SUBJECT: PURDUE UNIVERSITY - REQUEST FOR ADDITIONAL INFORMATION  
REGARDING THE PURDUE UNIVERSITY REACTOR LICENSE RENEWAL (TAC NO. ME  
1594), RESPONSES TO RAIs (ML103400115 and ML103400250)

**REQUESTED ADDITIONAL INFORMATION IN RESPONSE TO RAIs**

**REGARDING THE PURDUE UNIVERSITY REACTOR LICENSE RENEWAL (TAC NO. ME 1594)**

Figure 13-1: Power and Clad Temperatures for 0.6%Δk/k step insertion with scram.

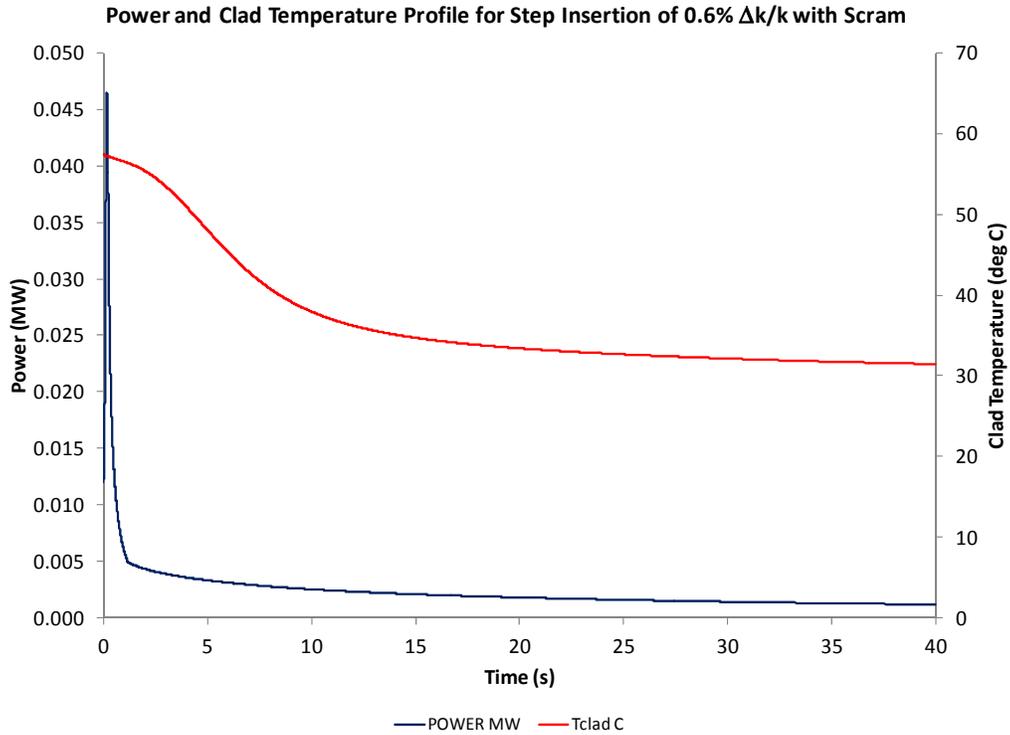
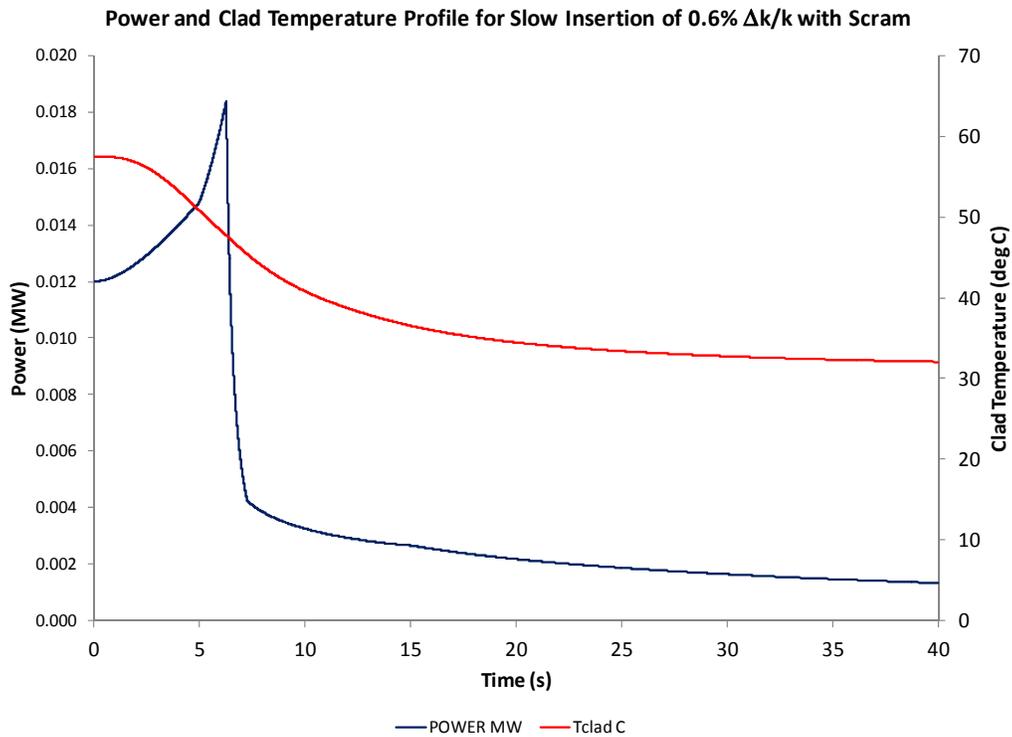
**A. For the scram assumption scenario, the accident is assumed by PUR-1 to be initiated at a power of 10 kW and scram is assumed to occur on a power trip at 12 kW. This assumption, however, does not appear to account for the power measurement error and uncertainty.**

*Please revise the assumption for this calculation and provide an evaluation of a safety analysis at the requested maximum licensed power level including power level measurement uncertainty.*

SCRAM	Reactivity Inserted	P0 (kW)	Pmax (kW)	Time of Peak Power (s)	T <sub>clad,max</sub> (°C)		
					at t=0	at Peak Power	Max
YES	0.6% $\Delta k/k$ step	12	46.4	0.173	57.40	57.40	57.40
YES	0.6% $\Delta k/k$ over 10 s	12	18.4	6.25	57.40	47.75	57.45

These results demonstrate the ability of the LSSS to protect the safety limit of fuel temperatures not to exceed 530°C. The maximum temperatures achieved in the fuel are well below temperature of incipient boiling as well. Therefore PUR-1 can maintain the fuel integrity during this accident scenario.

Figure 13-3: Power and Clad Temperatures for 0.6% $\Delta k/k$  step insertion without scram.

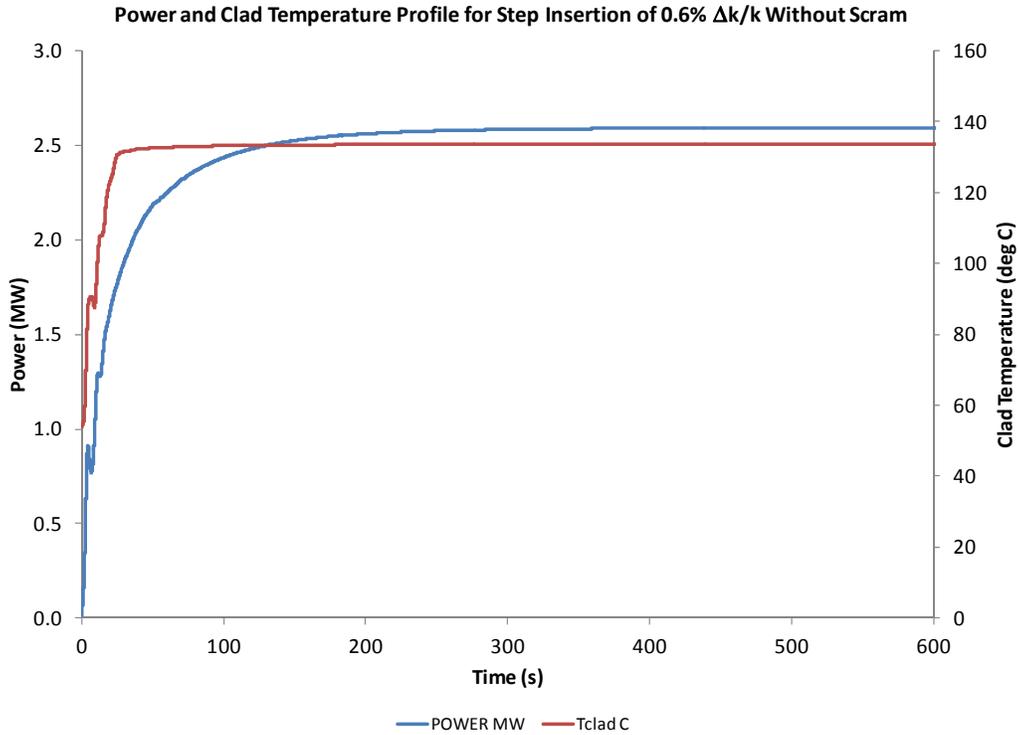
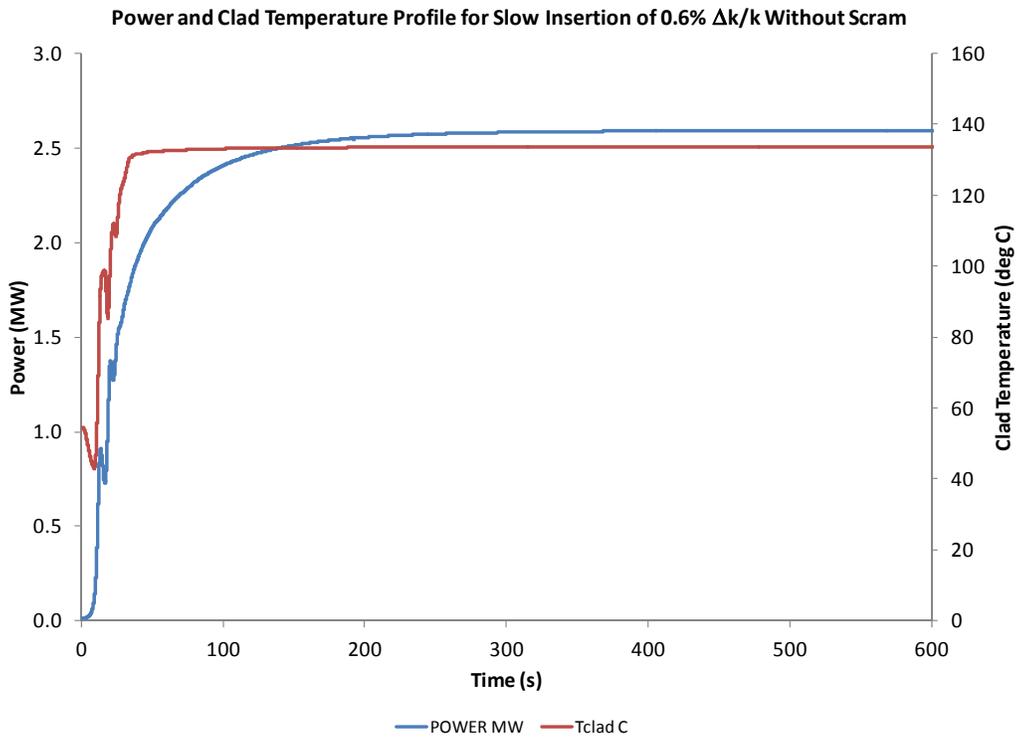
***B. For the no-scram assumption scenario, the initial power assumed by PUR-1 before the accident is 10 kW and does not appear to account for the power measurement error and uncertainty. Please revise the assumption for this calculation and provide an evaluation of a safety analysis at the requested maximum licensed power level including power level measurement uncertainty.***

Table 13-16: Peak power and clad temperature for trip and no-trip insertions of 0.6%  $\Delta k/k$ .

SCRAM	Reactivity Inserted	P0 (kW)	Pmax (kW)	Time of Peak Power (s)	Tclad,max (°C)		
					at t=0	at Peak Power	Max
NO	0.6% $\Delta k/k$ step	12	2591	674	54.43	133.56	133.56
NO	0.6% $\Delta k/k$ over 10 s	12	2591	690	54.43	133.56	133.56
